# Planning Scheme Amendment C339ggee Flood overlays and zones

## REVIEW OF COMPLEX SUBMISSIONS – LARA, AVALON AND FYANSFORD

City of Greater Geelong

July 2022

## Map 8 - Fyansford

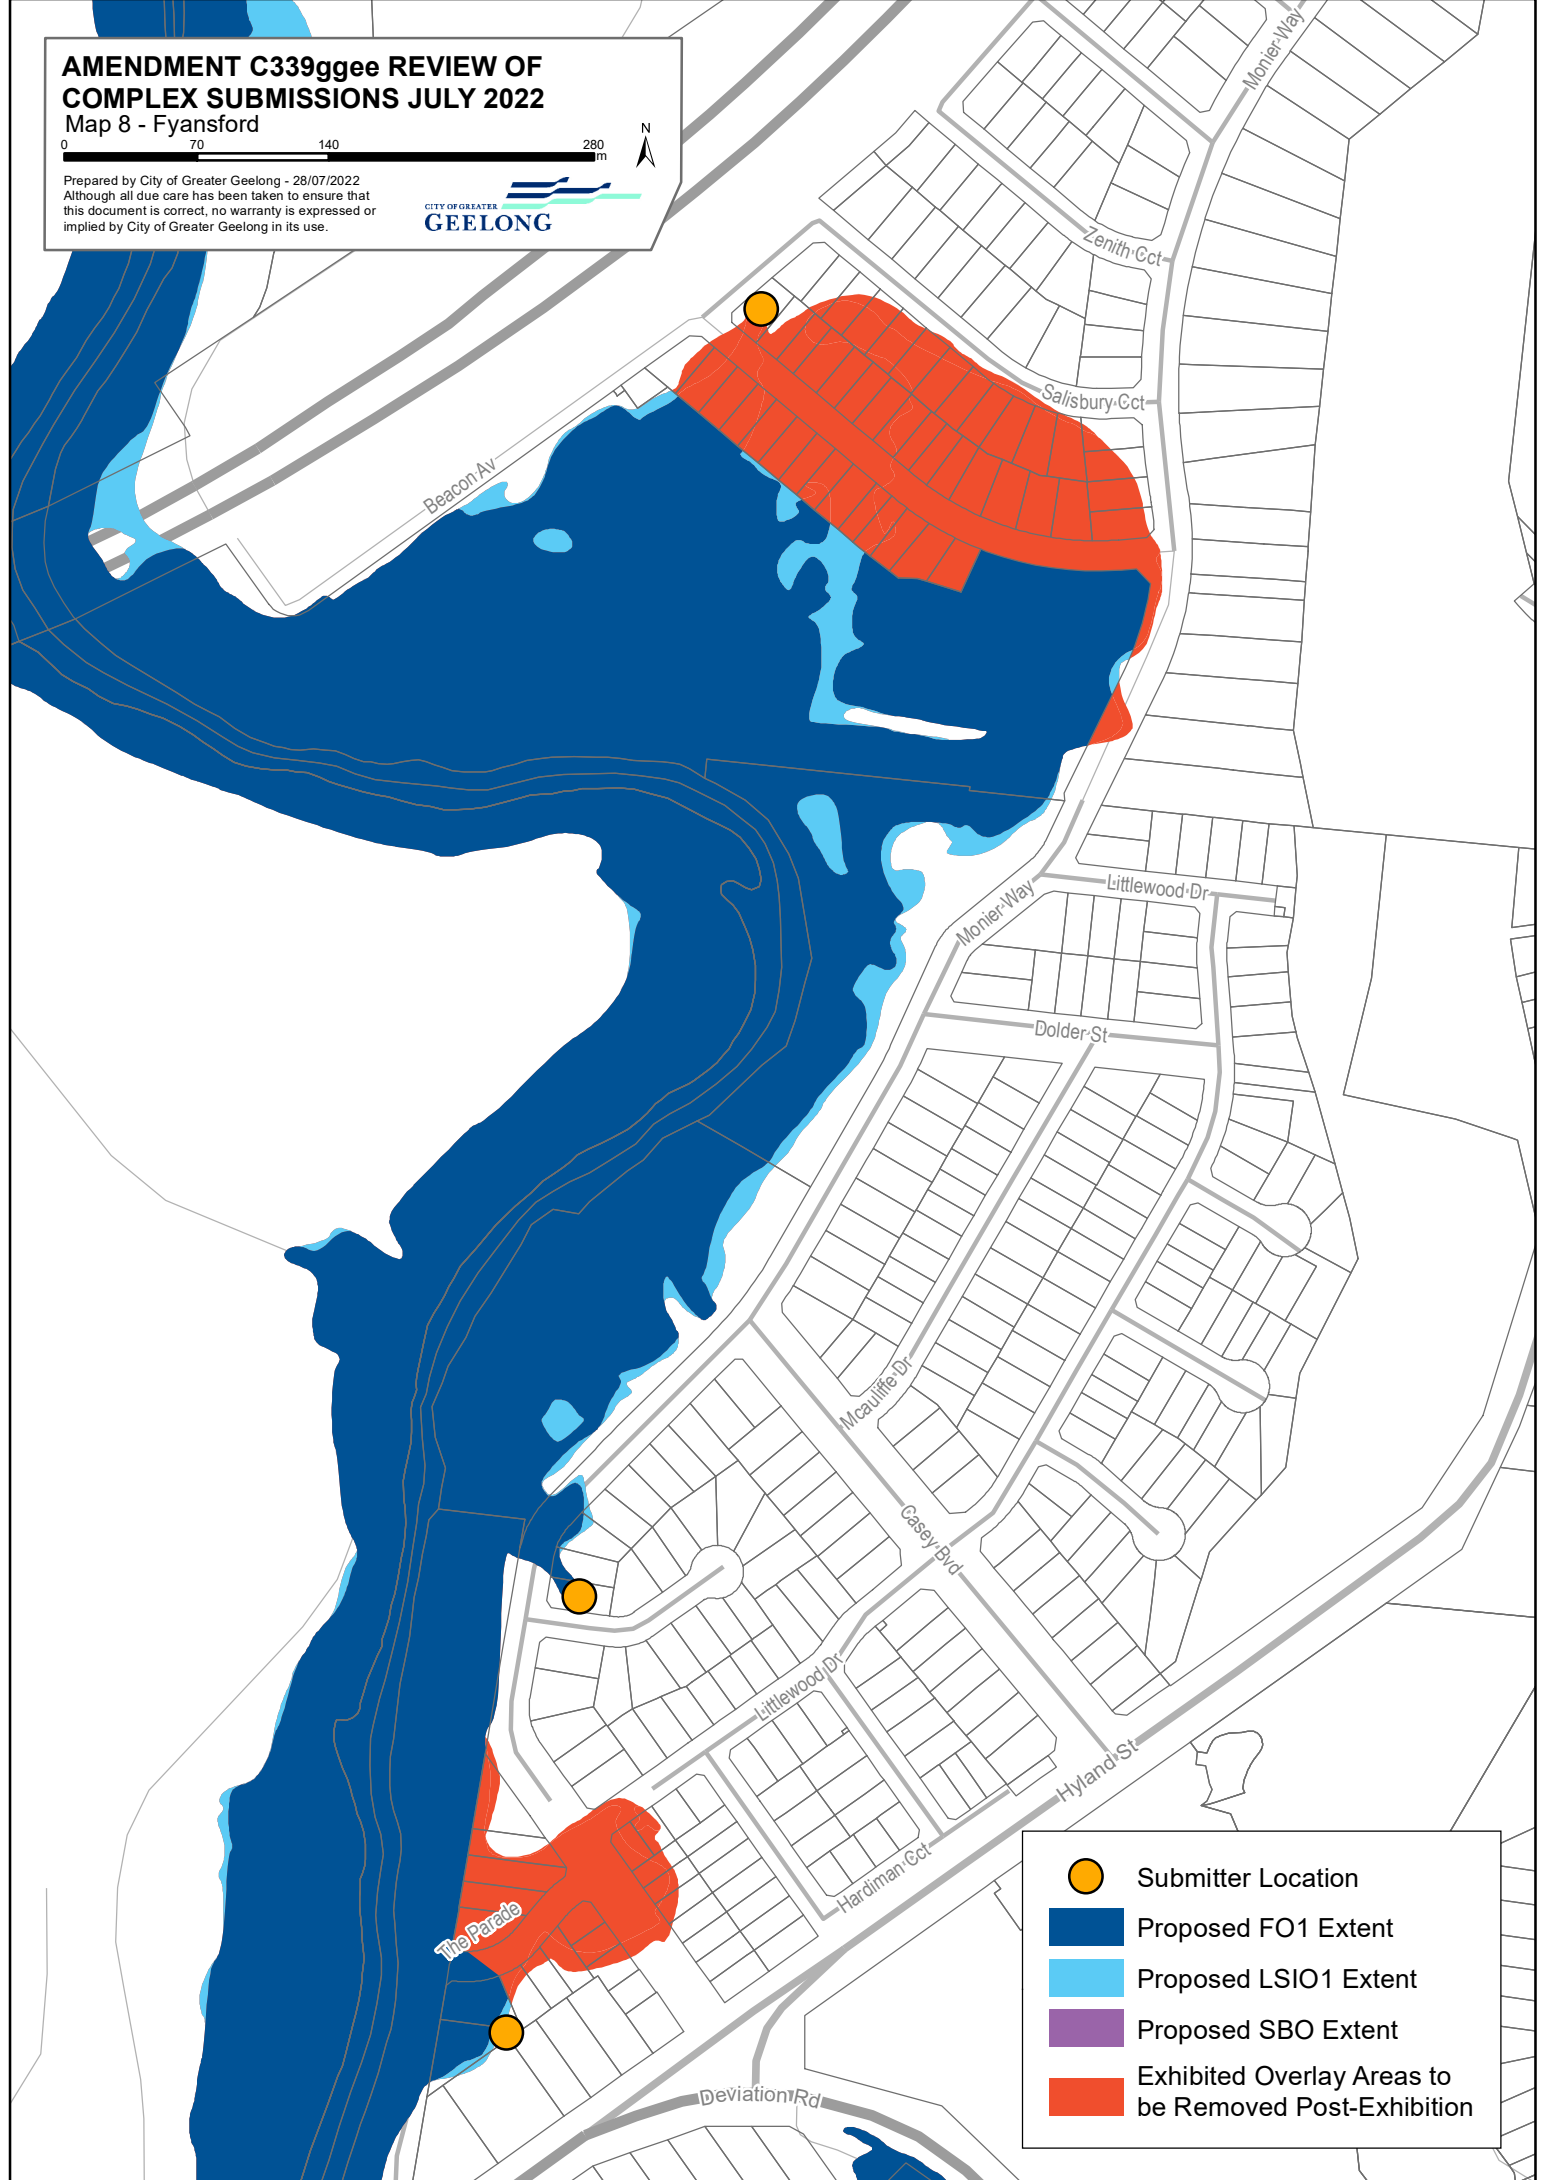
78			Fyansford	<b>Water Technology Consultants</b>		<p>Submitter 78 Cardno TGM lodged an objection related to land known as the Heights Estate at 355 Church Street, Herne Hill. They state: On 19 August 2014 Planning permit PP-107-2012/A was issued for the subdivision of land at 355 Church Street, Herne Hill in accordance with endorsed plans which includes the area of land now proposed for a Flood Overlay. Since then, the Heights Estate subdivision has now been completed. The planning permit for the subdivision of this land was supported by the Heights Development Flood Impact Assessment 2017 developed by BMT WBM. The Assessment determined that the subject land is not flood prone under development conditions... we are therefore surprised to now see that part of this land is now deemed to be flood prone as determined by this amendment.</p>	<p><u>Summary of response (see Water Technology Memo 12 May 2022 for full comments):</u></p> <p>The Lower Barwon and Lower Moorabool Flood Study was based on topographic information derived from aerial survey collected in January 2017. At this time "The Heights" estate had commenced some earthworks but filling of this area had not begun. This means that raised ground levels resulting from the development were not incorporated into the hydraulic modelling.</p> <p>The 1% AEP design flood level and corresponding flood extent on which the Land Subject to Inundation Overlay is based is around 8.3 m AHD in this area.</p> <p>It is understood that ground levels within the lowest sections of the estate have now been raised. Approved plans provided to council indicate that ground levels within Salisbury Circuit and the sections shown to be flooded under the exhibited overlay have been raised to at least 9.4 metres AHD within the land on the southern side of Salisbury Circuit.</p>	Yes - exclude from overlay See Map 8

Sub No.	Surname	Property Address	Suburb (Growth Area)	Reviewed by:	Proposed Planning Control	Summary of Submission	Response	Change to maps?
							 <p><b>Figure 3 Recommended Floodway and Land Subject to Inundation Clip Line</b></p>	
269		The Parade	Fyansford	<b>Water Technology Consultants</b>		<p>Raised questions and concerns about the extent of the overlays in the area which is a relatively new housing estate next to the Moorabool River.</p>	<p><u>Summary of response (see Water Technology Memo 12 May 2022 for full comments):</u></p> <p>The topographic information on which the Lower Barwon and Lower Moorabool Flood Study was based on aerial survey collected in January 2017. Ground levels on the subject property are understood to range between 7.1 – 7.6 metres AHD. The 1% AEP design flood levels and corresponding flood extent on which the Land Subject to Inundation Overlay is based, are around 8.15 m AHD in this area. The topographic data is shown in Figure 10. Figure 11 shows a comparison between current and exhibited flood overlays.</p> <p>At the time of the flood study the “Gen Fyansford” estate had commenced earthworks but filling of this area had not occurred. This means that raised ground levels as part of the development were not incorporated into the modelling or extent mapping. A detailed review of construction plans indicates that flood protection works within the estate do not extend to the subject property. The Gen Fyansford estate is filled above the applicable</p>	<p>Yes - exclude from overlay See Map 8</p>

Map 9 - Ballan Road

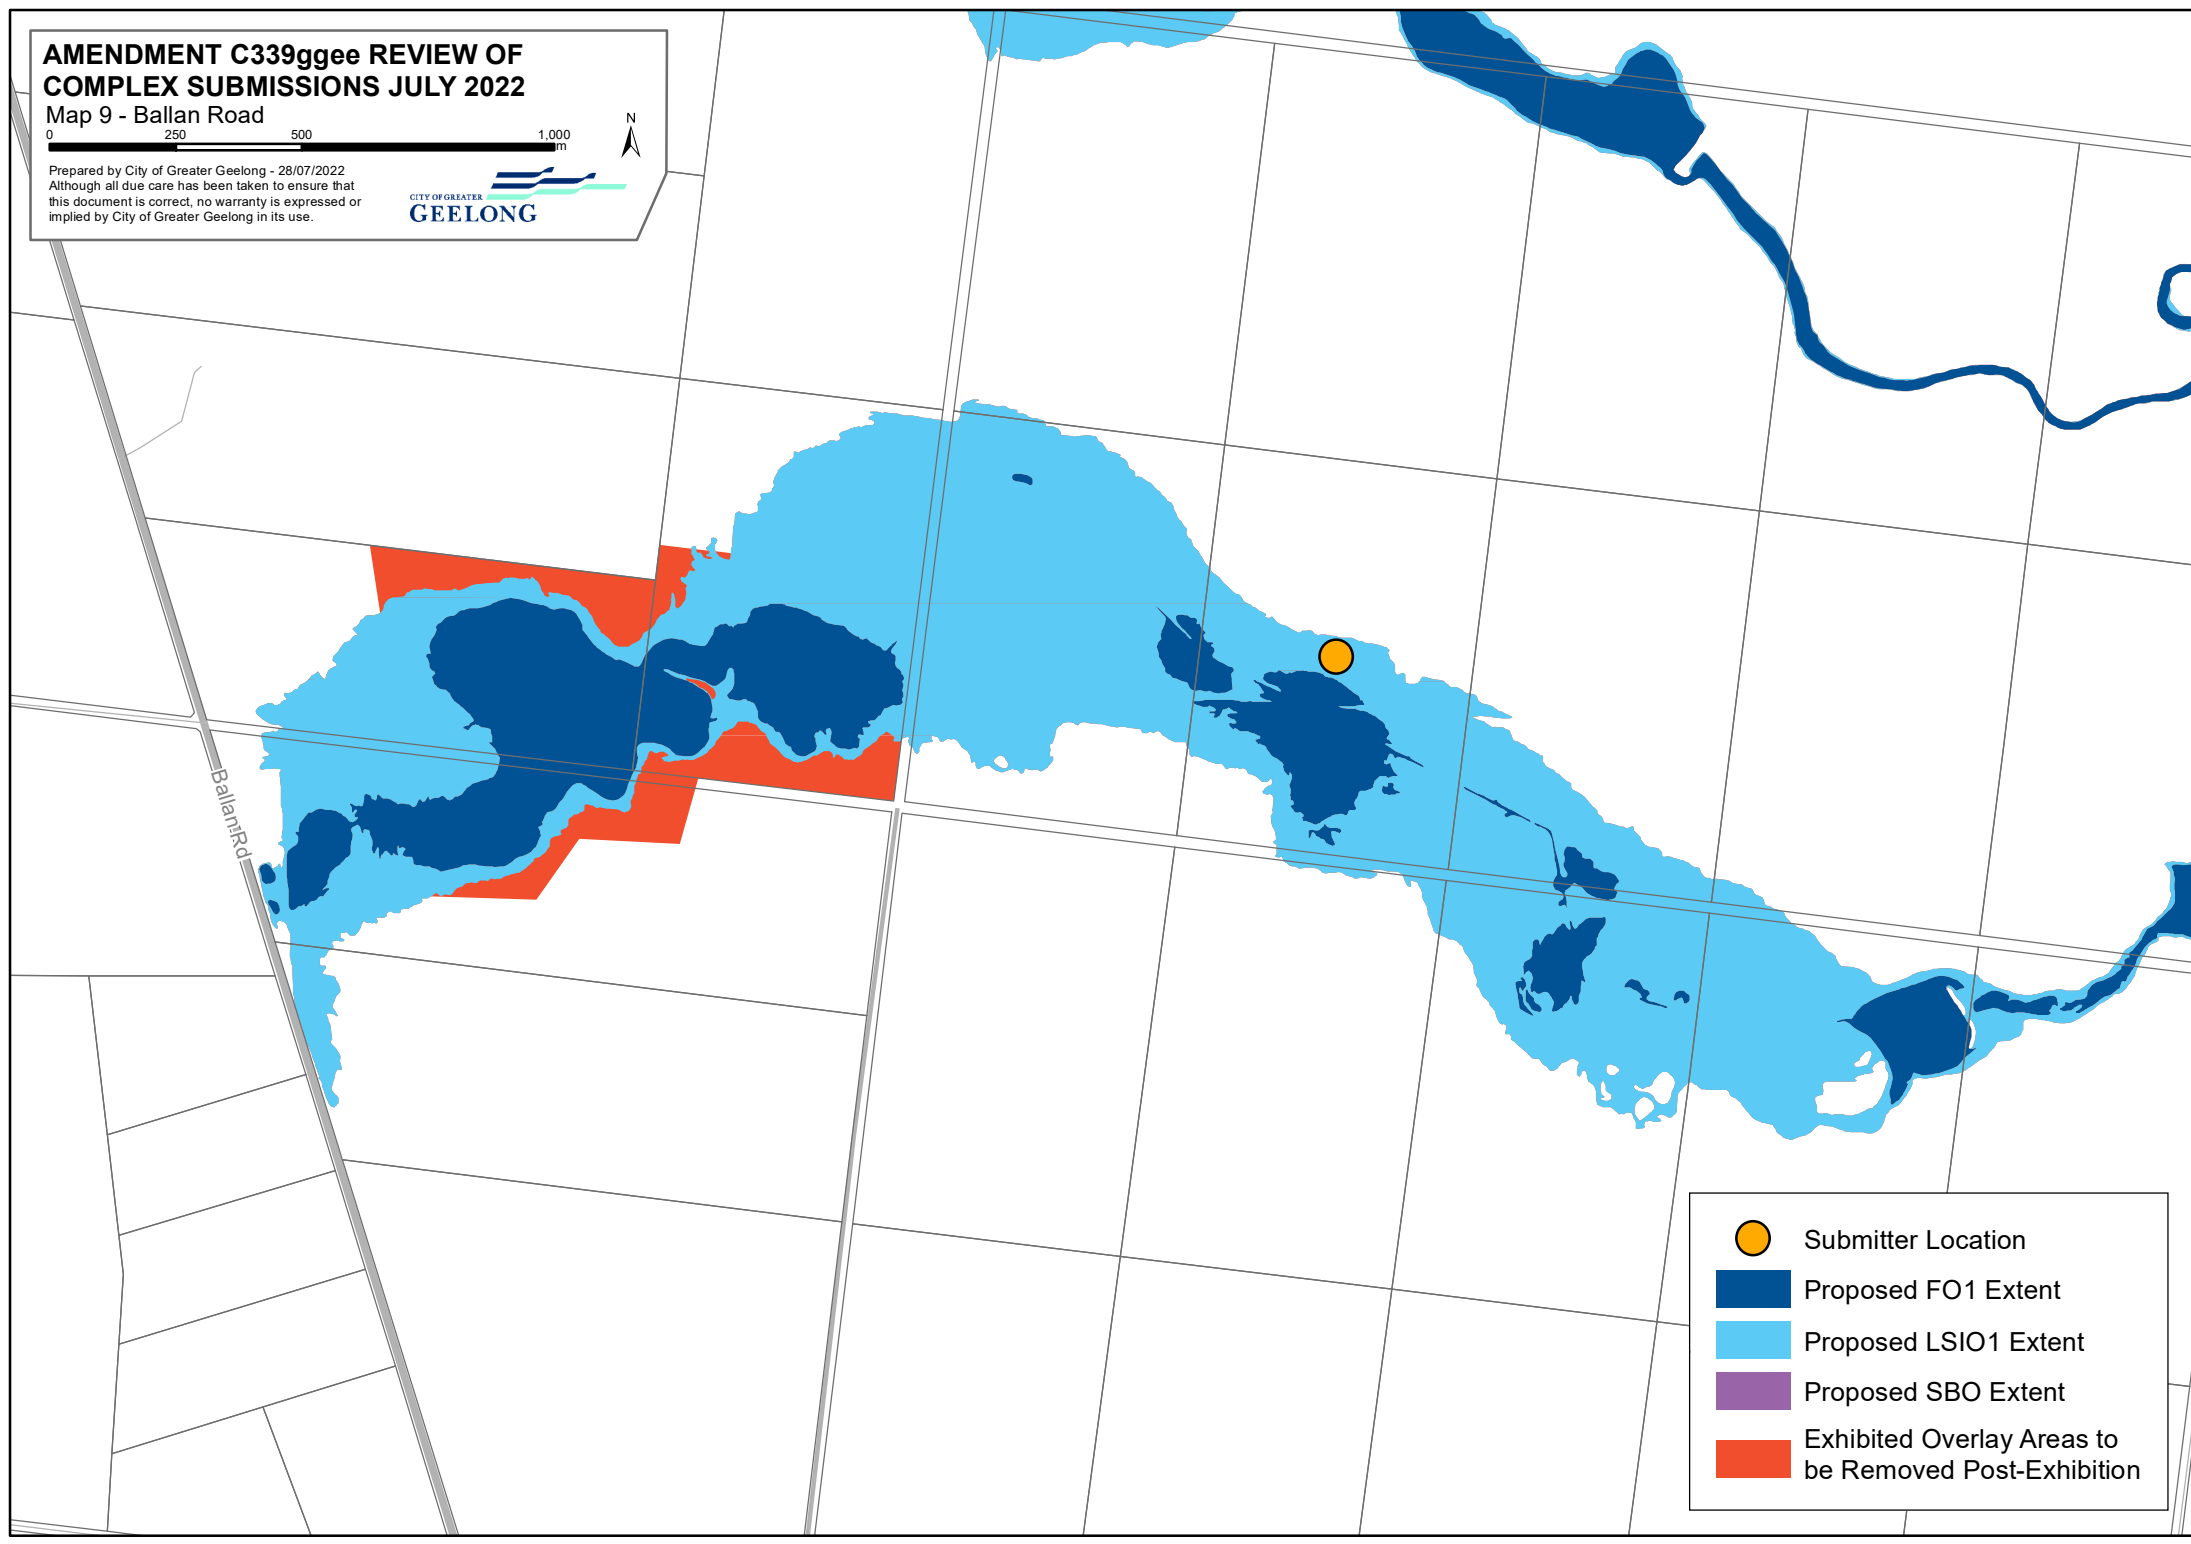
Sub No.	Surname	Property Address	Suburb (Growth Area)	Reviewed by:	Proposed Planning Control	Summary of Submission	Response	Change to maps?
177	Individual Submitter	Ballan Rd	Anakie	Corangamite Catchment Management Authority (CCMA)	FO1, LSIO1	Includes a marked-up copy of exhibited FO LSIO map with elevations from GoogleEarth. Submits flooding & inundation in the Anakie area only occurs as the result of poor construction and maintenance of roads preventing the natural dispersion of water.	<p>Topographic data used in the study is up to date and more accurate than that available from Google Earth.</p> <p>Flood modelling does not allow water to flow uphill.</p> <p>CMA notes this is at a boundary of the flood model (i.e. inflow location) which may skew results. This is not expected to influence the extent greatly but may have a small impact</p> <p><b>Change recommended - Amendment mapping appears to have merged old maps with new. This should be rectified.</b></p>	Yes - amend maps to correct mistake See Map 9

Figure 2 Topography comparison

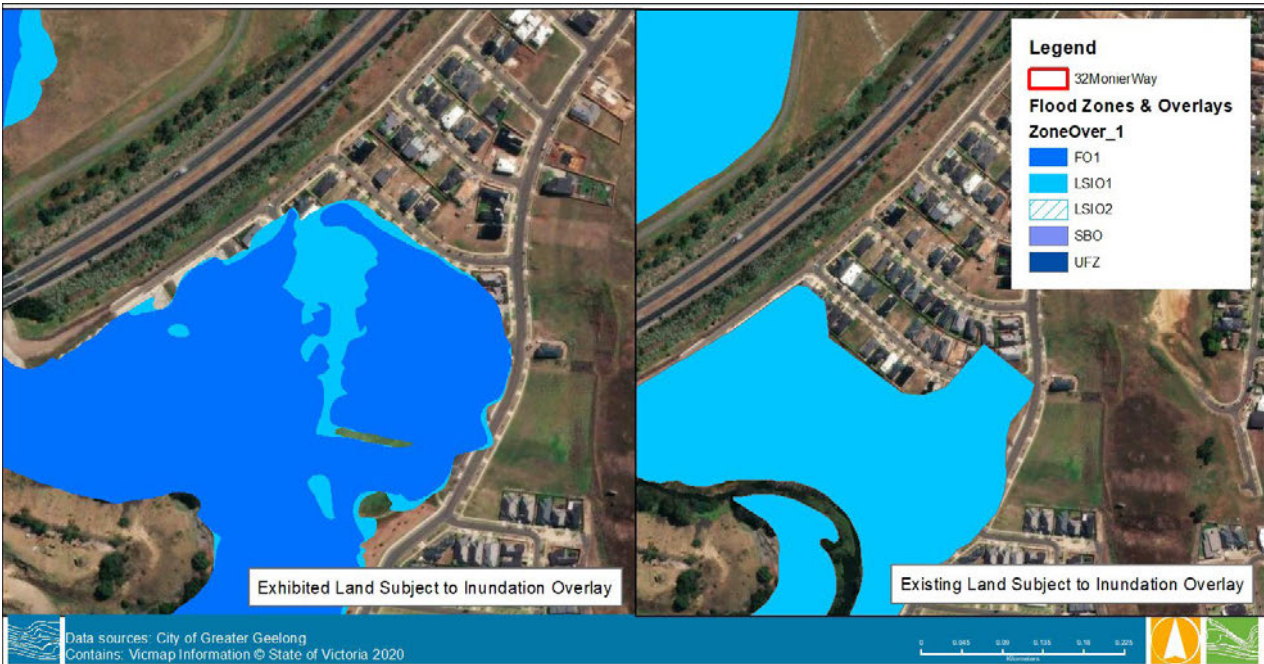
Figure 2 below, which compares the topography from the Lower Barwon and Lower Moorabool River Flood Study with more current survey levels. Figure 3 show the existing and exhibited LSIO layers side by side. This highlights that the exhibited layer is not reflective of the current topography as discussed above.

It is therefore recommended that the exhibited LSIO map be clipped to the extent of filling within the Heights development. The Figure 4 below shows the exhibited clipped flooding extent at the location (dashed red line).

Figure 6 Topography Comparison

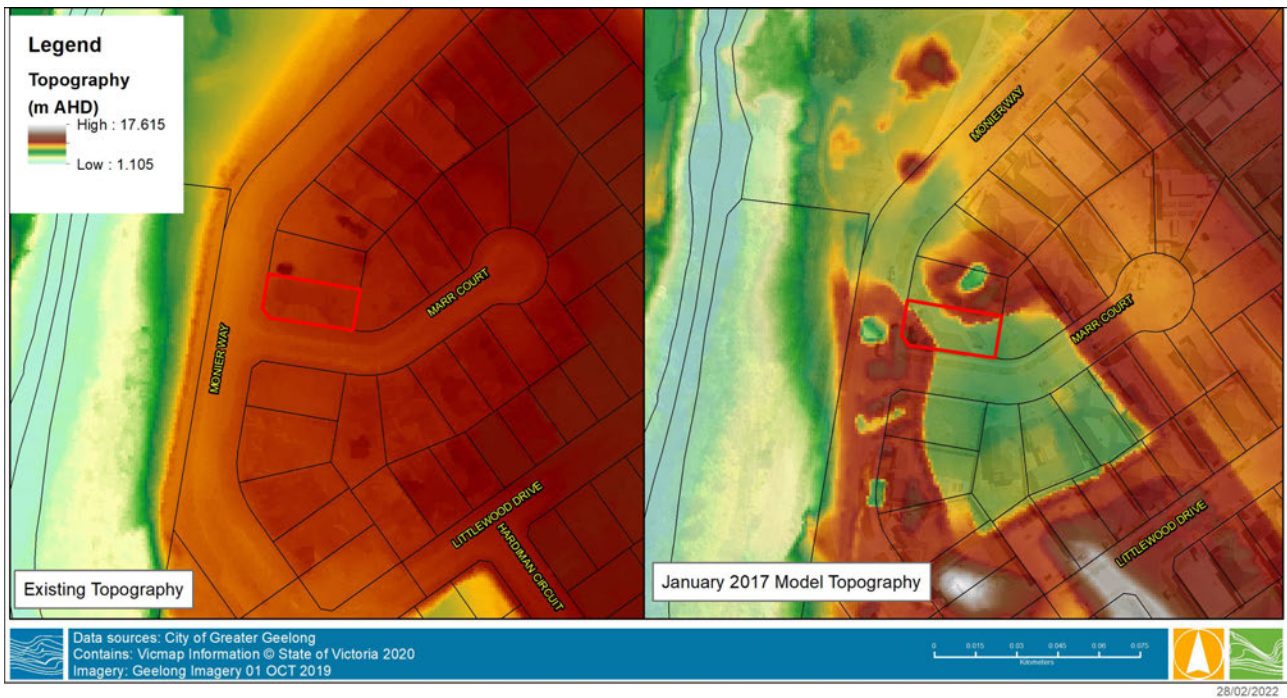
It is understood that ground levels within the lowest sections of the estate have now been raised. Approved plans provided to council indicate that ground levels within Monier Way and the sections shown to be flooded in the exhibited C339 overlay have been raised to 9.3 – 9.6 metres AHD along Monier Way. Figure 6 shows a side-by-side comparison of the existing and flood-study topography, highlighted where the lots have been filled. Figure 7 shows a comparison of the existing and exhibited LSIO layers.

It is therefore recommended that the exhibited LSIO map be clipped to the extent of filling within this area of development. The Figure 8 below shows the exhibited clipped flooding extent at the location (dashed red line).

Figure 10 Topography Comparison

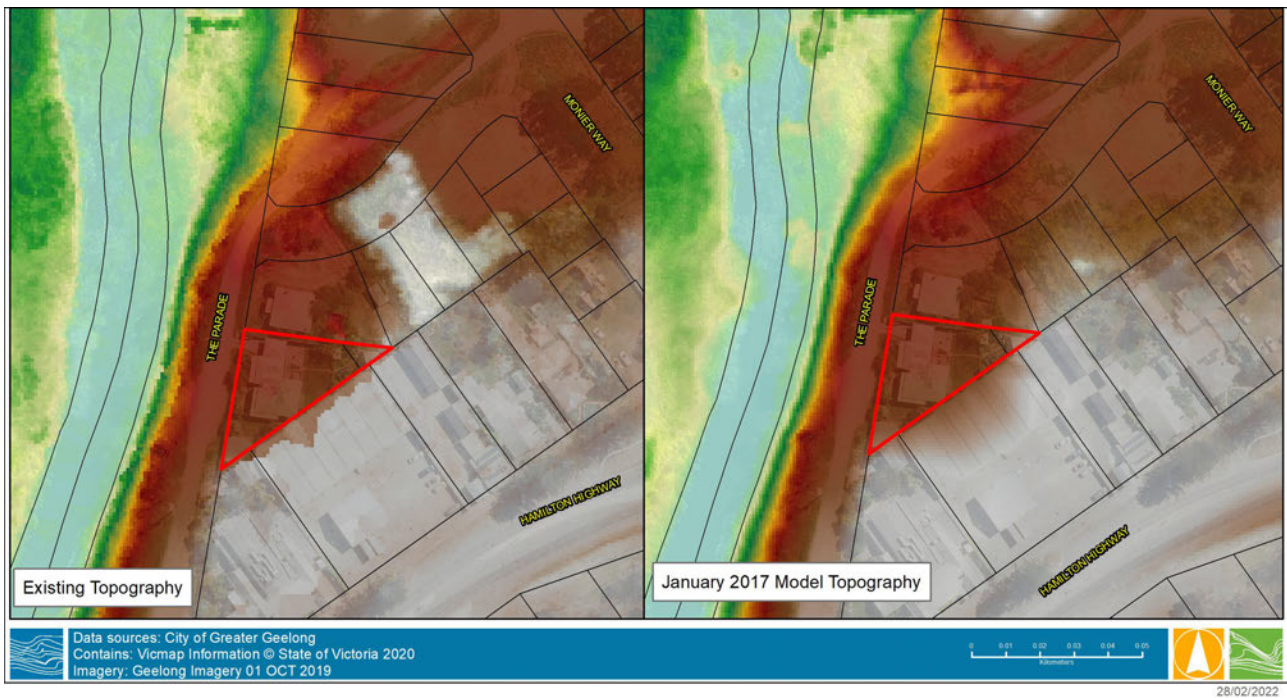
The topographic information on which the Lower Barwon and Lower Moorabool Flood Study was based on aerial survey collected in January 2017. Ground levels on the subject property are understood to range between 7.1 – 7.6 metres AHD. The 1% AEP design flood levels and corresponding flood extent on which the Land Subject to Inundation Overlay is based, are around 8.15 m AHD in this area. The topographic data is shown in Figure 10. Figure 11 shows a comparison between current and exhibited flood overlays.

Whilst it is acknowledged that the existing flood modelling within this section of the floodplain does not account for filling of the Gen Fyansford estate, the impact of filling is likely to be localised and only provide flood immunity to the areas shown to be filled above the applicable flood level. Having regard to this it is recommended that the LSIO and FO extent in this location be clipped to match the filled area as shown in Figure 12.
